S A V A N N A H H I S T O R I C D I S T R I C T
B O A R D O F R E V I E W

REQUEST FOR CERTIFICATE OF APPROPRIATENESS

MPC File No.: 26-003519-COA

Address: 111 Martin Luther King, Jr. Blvd.

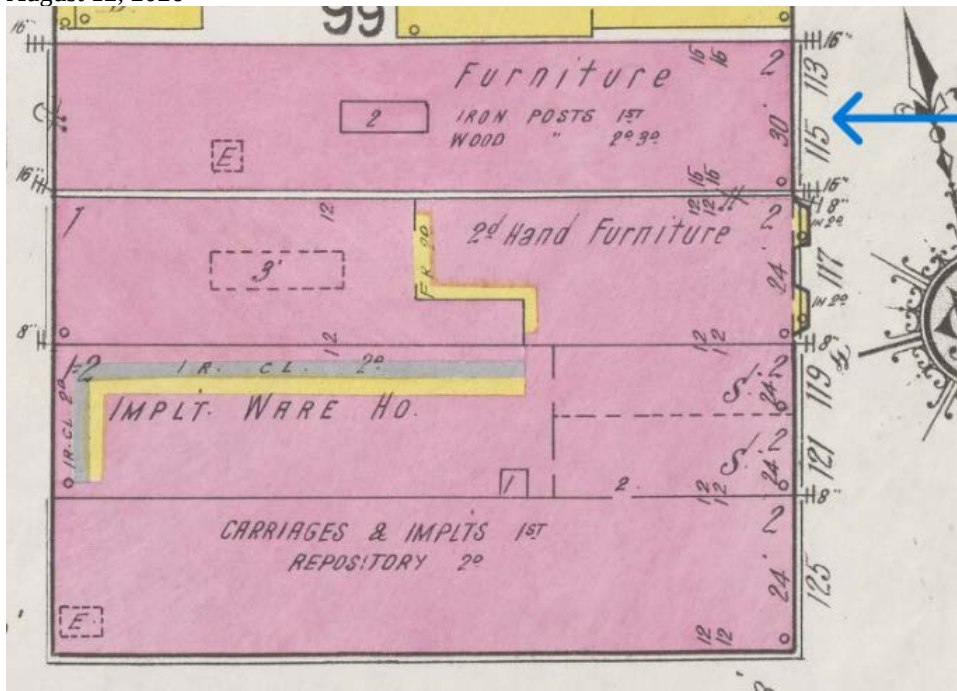
Front (east) façade: replace all existing windows, including storefront windows, repair the existing wood cornice in-kind, changing one window opening into an exit door opening.
